SUBJECT: FAULTING IN UNIT 1 ESW PUMPING STATION AND  
UNIT 2 TURBINE BUILDING AREA

## PHIPPS BEND NUCLEAR PLANT

### Fault Zone In The Rock Foundation For The Unit 2 Turbine Building

PHIPPS BEND NUCLEAR PLANT  
REVERSE AND TRANSVERSE FAULTS  
IN THE UNIT 1 ESW PUMPING STATION

UNIT 2 TURBINE BUILDING

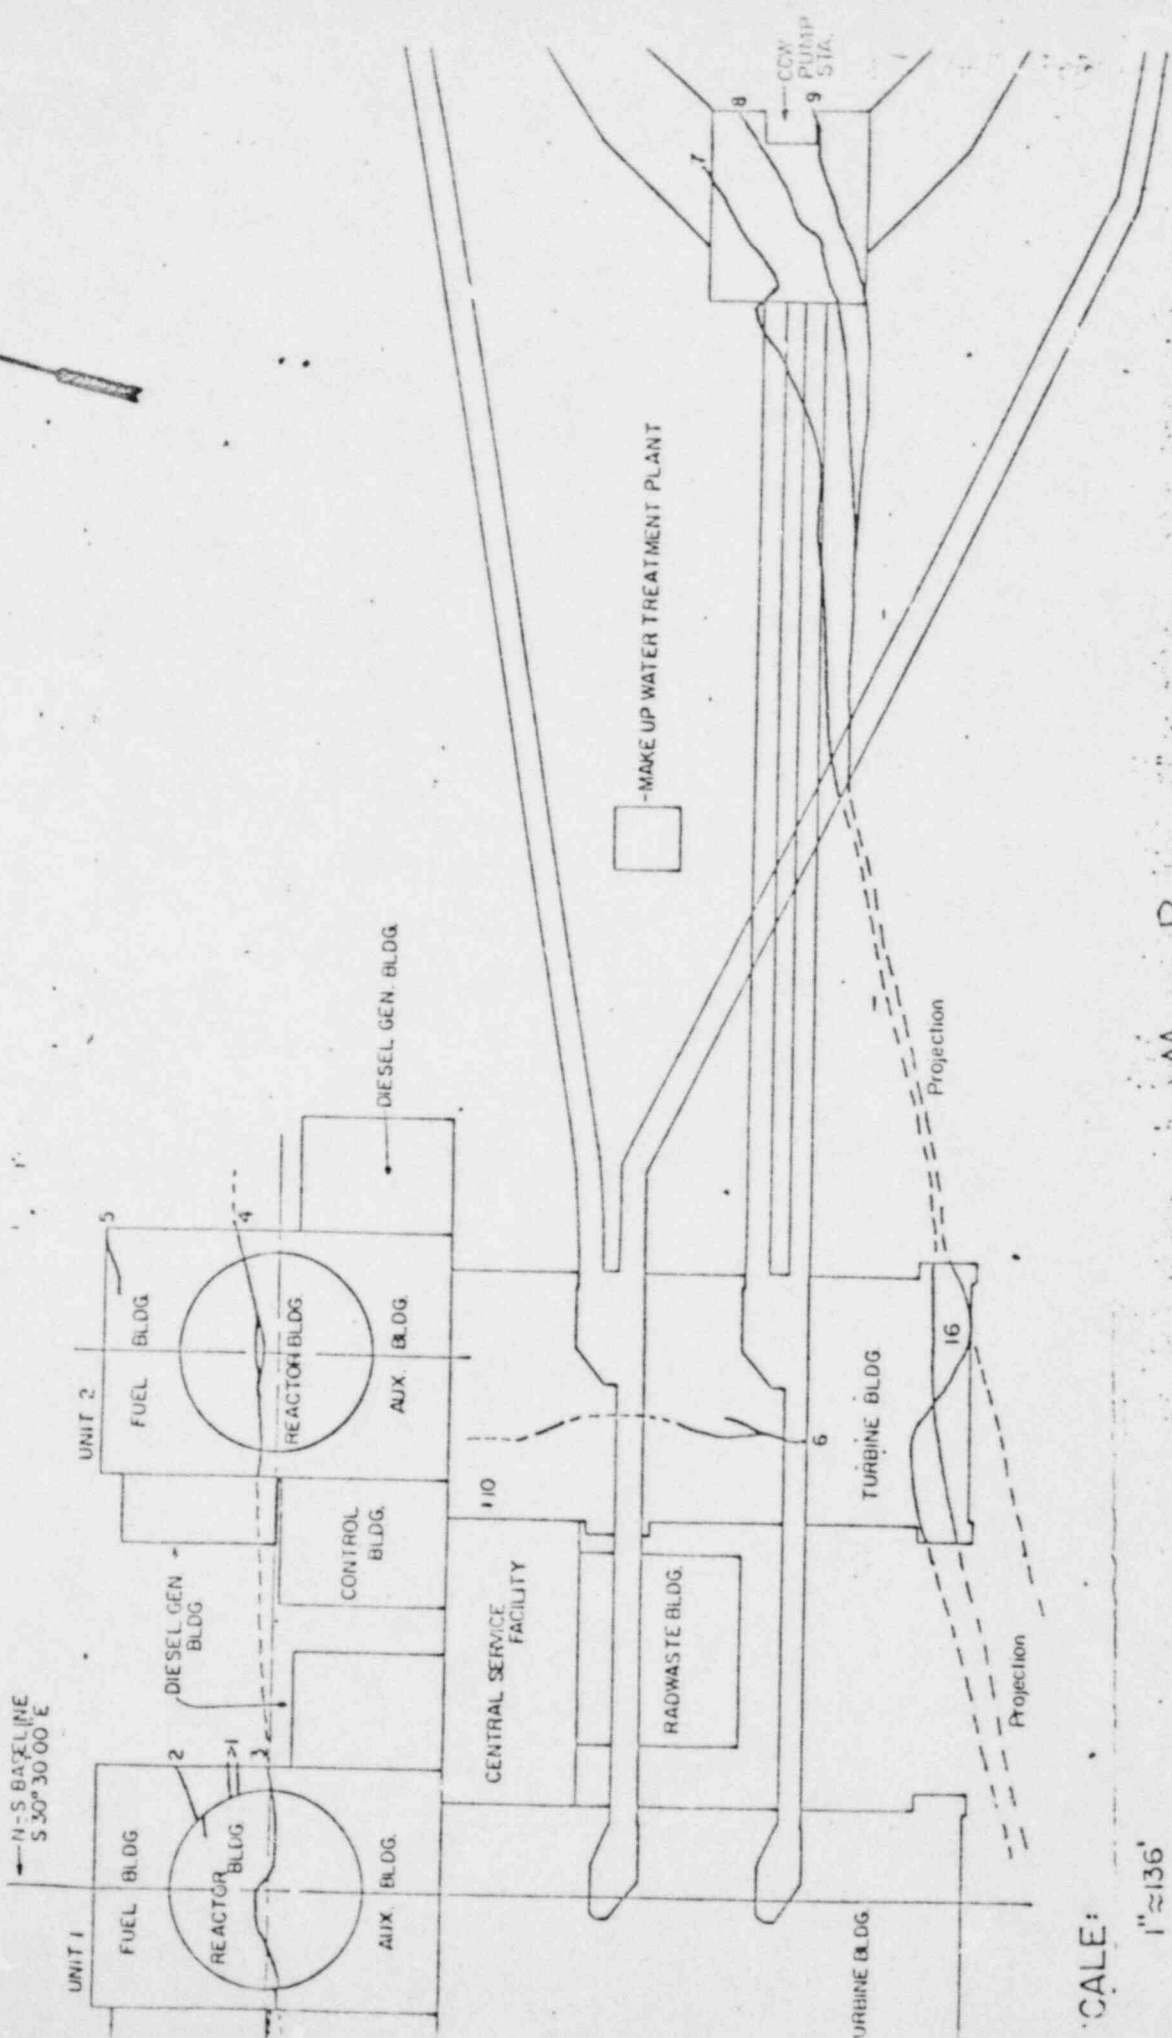
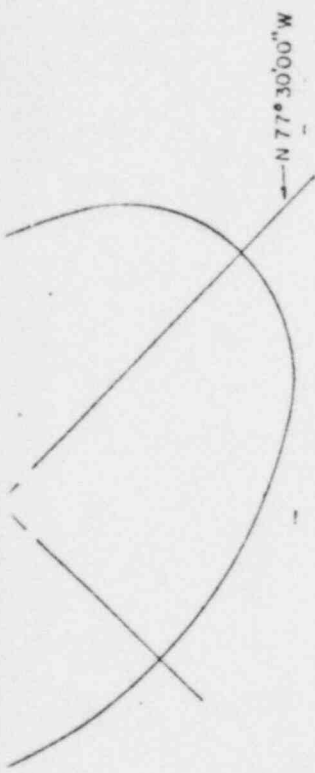
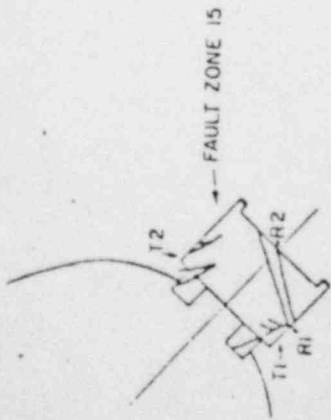
Continued excavation of the weathered rock in the south end of the Unit 2 turbine building has exposed complex folding and faulting (see attached map A).

This area is defined by a weathered, faulted, contorted rock zone striking approximately N 50° E and dipping from horizontal to vertical, but generally parallel to the regional dip. On the east perimeter of the turbine building excavation, the faults extend under the overburden. They are exposed again by excavation 300 feet to the east in the CCW trench, from which they can be traced along the excavated rock surface to the CCW pumping station (see attached map B).

This fault zone (designated number 16) is an extension of faults 7, 8 and 9, located in the CCW pumping station foundation. This was reported to NRC in a memorandum from J. E. Gilliland to H. W. Denton, dated April 30, 1979 (MEB 790502 521).

Examination of the overburden-rock contact around the perimeter of the excavation has revealed no offsetting of Quaternary terrace deposits. The folds and faults in the Unit 2 turbine building excavation show no evidence which would indicate that they did not occur in the early tectonic development of the Paleozoic (250+ million years) folding and faulting in this area. These faults, having been stable for 250 million years are not considered to be capable of producing ground offsets or generating earthquakes. Therefore, we do not classify them as capable faults, within the meaning of Appendix A to 10CFR part 100.

Based on the NRC staff's evaluation of these reports, similar past TVA reports and the resulting staff fault evaluations (e.g. November 5, 1979), the staff considers fault zones 15 and 16 to be associated with deformational activity related to the region's early geologic history, sometime before 250 million years before present. In addition, the staff agrees with TVA in that Fault zone 16 is the extension of faults 7, 8 and 9. Faults 7, 8 and 9 are discussed in the July 18, 1979 memorandum from R. Jackson to Robert Baer. Therefore, the staff considers the faults non-capable within the meaning of Appendix A to 10 CFR Part 100.

FAULT ZONE 15

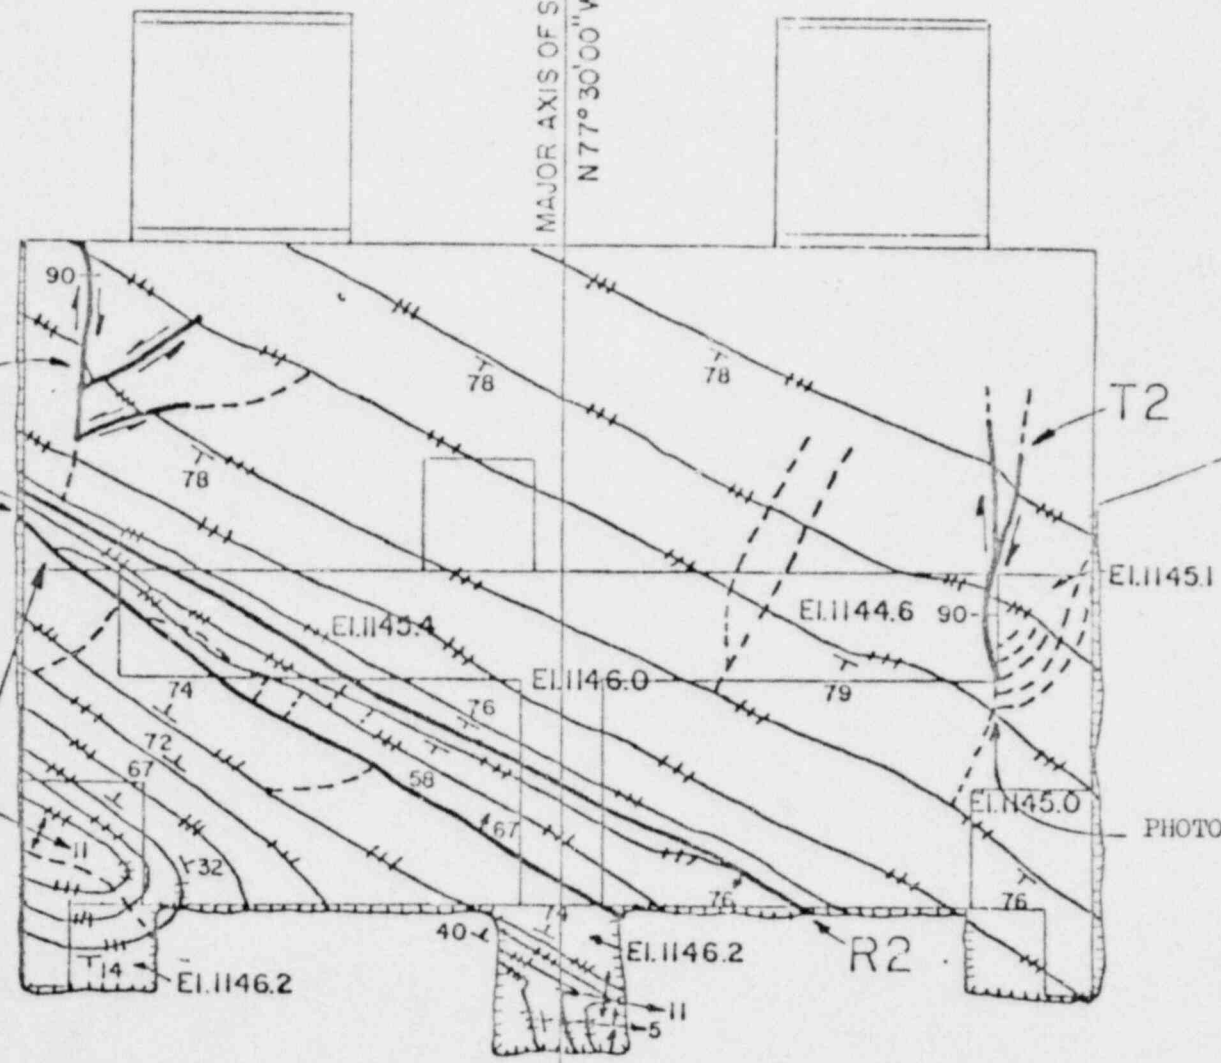
Geologic mapping of foundation bedrock in the Unit 1 ESW pumping station has revealed two reverse faults in the southeast quadrant of the building, and two transverse faults located west of the reverse faults. They are grouped as fault zone 15 and designated R1, R2, T1, and T2 (see attached photos and drawing for locations).

Faults R1 and R2 are reverse faults parallel to the axis of an anticline to the southeast. R1 dips  $67^{\circ}$  NW. and strikes N.  $50^{\circ}$  E. R2 dips  $76^{\circ}$  SE. and strikes N.  $50^{\circ}$  E. Both fault traces are defined by calcite-healed fractures that extend across the floor of the excavation from the south wall to the east wall of the building.

Transverse faults T1 and T2 are located west and northwest, respectively, of R1 and R2. T1 consists of three nearly vertical branches, one striking N.  $52^{\circ}$  W., and the other two striking N.  $10^{\circ}$  E. The fault traces are defined by calcite-healed fractures that offset bedding from 3 to 7 inches. T2 is 70 feet north of T1 and exhibits essentially the same characteristics.

All four faults described were formed during the Paleozoic Era and are characteristic of tectonic forces that developed during the formation of the Saltville fault family. These faults, having been stable for 250 my, are not considered to be capable of producing ground offsets or generating earthquakes. Therefore, we do not classify them as capable faults, within the meaning of Appendix A to 10 CFR Part 100.
